BID NUMBER: S7YK1220
TITLE: Emergency Abatement Repair Program
DEPARTMENT: WATER DEPARTMENT-OPERATIONS DIVISION
DATE TO OPEN: April 25, 2016 at 10:30 AM

ADDENDUM # 1

**Emergency Abatement Repair Program
Invitation & Bid No. #S7YK1220
Non-Mandatory Pre-Bid Meeting of Thursday, April 7, 2016
Questions and Answers**

Revisions / Modifications: Page 2, Paragraph 1.2 Contract Term:

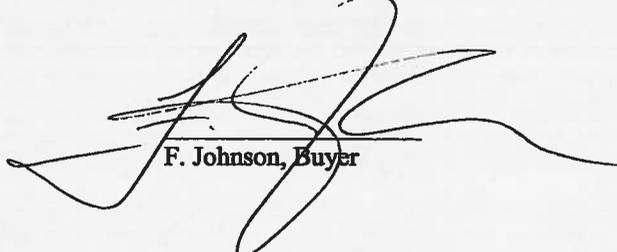
The following Contract Term Date of 10/01/2016 to 9/30/2017 ("Initial Term") is hereby revised as follows:

Contract Term: Date of Award through One Year ("Initial Term")
